ALMA CHANGE REQUEST

Date submitted: 2012-04-30
CRE #: FEND-40.02.10.00-0000-A-CRE

TITLE:
Change Request for the Band 10 Cartridge Noise Performance (DRAFT!)

Figure 1. DSB noise temperatures of the first six Band 10 cartridges as a function of LO frequency. A blue dashed-line shows the noise performance specification of 230 K over 80% bandwidth.

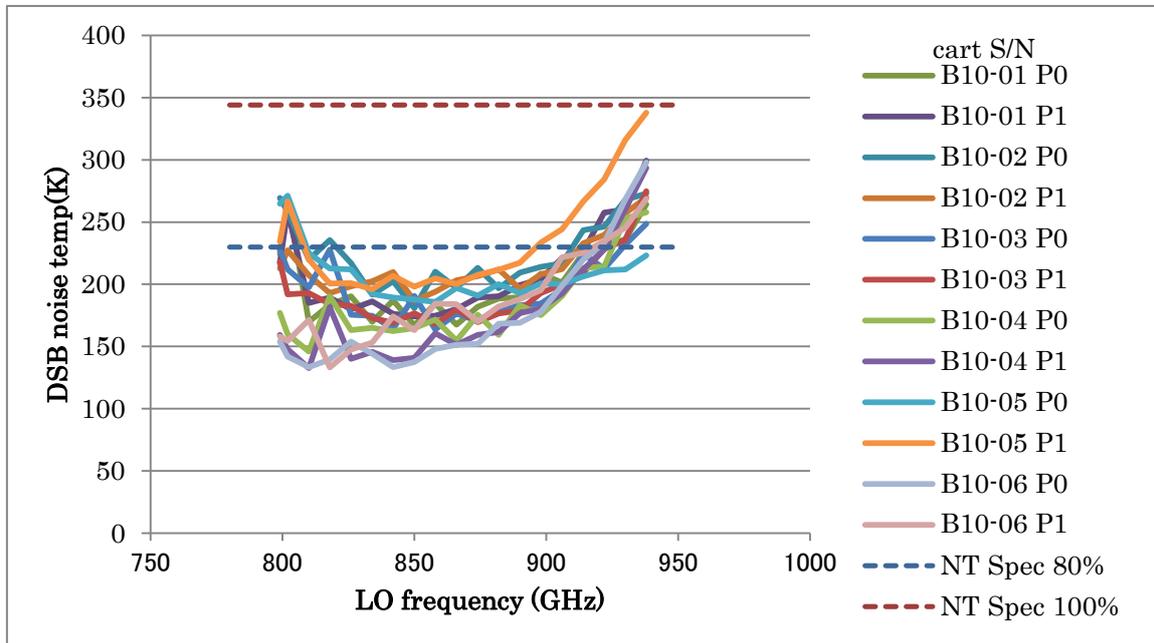
Although all pre-production cartridges are compliant with the requirement of less than 344 K for the bull-band, three cartridges out of six did not meet the specification of less than 230 K over 80% of the band as shown in Figure 1 [RD 01]. Figure 2 shows the noise performance in the worst case, which has 58% bandwidth below 230 K [RD 02].

To 230 K over 60% of the frequency range

Figure 2. Noise performance of CCA10-05 Pol. 1 (the worst case of 58% bandwidth in the first six cartridges).

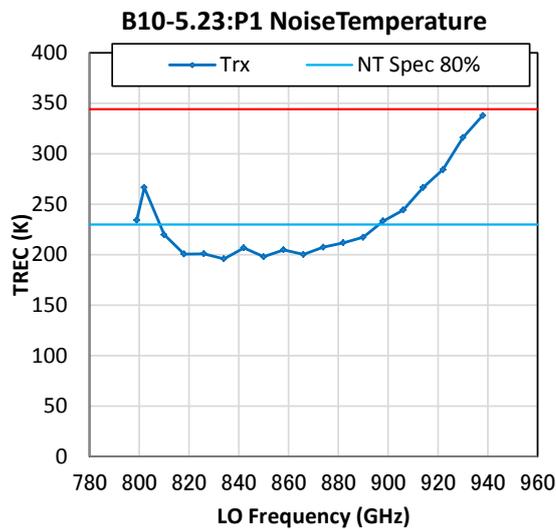
Another cause to increase the noise performance is thought to be excess LO noise. For example, in Figure 2, the noise increase at ~800 GHz can be seen, which may be due to the excess LO noise. The corresponding noise can be observed in measurements of noise temperature versus IF and LO frequency, as shown in Figure 3. This noise could be reduced by using a quasi-optical LO attenuator with a smaller diameter hole (larger attenuation). But simultaneously, the LO power to pump the SIS mixer will be decreased. Figure 4 shows an SIS pumped current as a function of LO frequency in full LO power operation as an example. The red line with closed squares shows optimum pumped currents for the receiver operation. The use of lager LO attenuation in the LO path would improve the receiver noise performance by decreasing the excess LO noise, but the noise performance at around 920 GHz is degraded due to a lack of LO power. Thus, it is difficult to improve the noise performance over all by changing the quasi-optical LO attenuator. More power-full LO sources will resolve this issue, as seen in the case of lower frequency bands. Or reduction of excess noise in the LO source will be necessary. However, the current LO technology limits these improvements.
